From: [John Brown](#)
To: [Nicole Tremblay](#); [Amy Nelson](#)
Cc: [Rebecca Paul](#)
Subject: RE: 214 Miami Ave - Planning Review
Date: Wednesday, September 6, 2023 11:25:25 AM
Attachments: [image006.png](#)
[image007.png](#)
[image008.png](#)
[image009.png](#)
[image010.png](#)
[image011.png](#)
[image001.png](#)
Importance: High

TO: Rebecca Paul, Planning Coordinator
FROM: Nicole Tremblay, AICP, Senior Planner
DATE: August 11, 2023
SUBJECT: HAPB Petition No. PLAR23-00157 – 214 Miami Ave

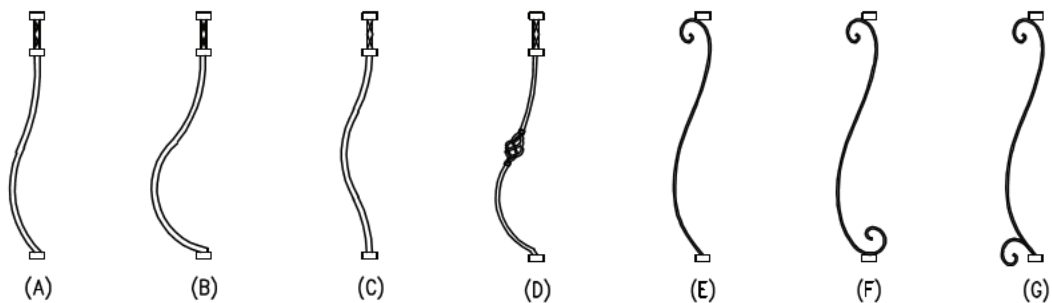
4. Please confirm compliance with Sections 7.10.7.D (recesses and/or projections) and 7.10.7.E (decorative features).

Our proposed design complies with Section 7.10.7.D for recesses and projects (having 2 or more of these features).

We have corbels/brackets, colonnade at the building front as well as balconies.

And also with 7.10.7.E as complying with F. ornamental relief design (all windows and doors) and B. Recessed Niches – provided at the rear of the building.
